Subject: RUST/PAINT BLISTER ON TRUNK LID AROUND LICENSE PLATE LIGHT	Bulletin No: 09-037/16
	Last Issued: 09/13/2016

2014-2016 Mazda3 (Japan built) vehicles with VINs lower than JM1BM*****351834 (produced before May 16, 2016)

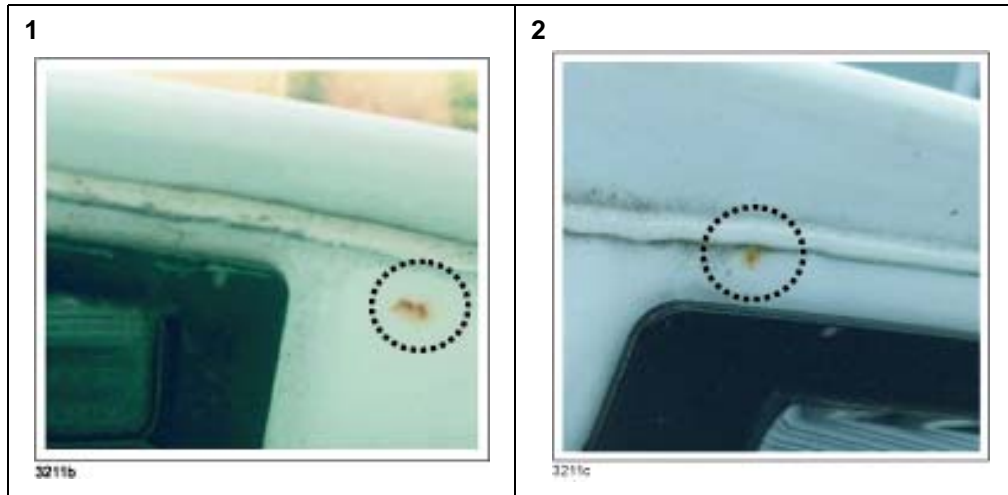
This is caused by one of the following issues:

1. The paint coating on the welding spots is not thick enough.
2. Water with iron particles is splashed up into this area around the sealant and the iron particles remain and start to rust.

1. The welding spots are ground down prior to painting.
2. The application method of the sealant has been changed so that iron particles will not remain.
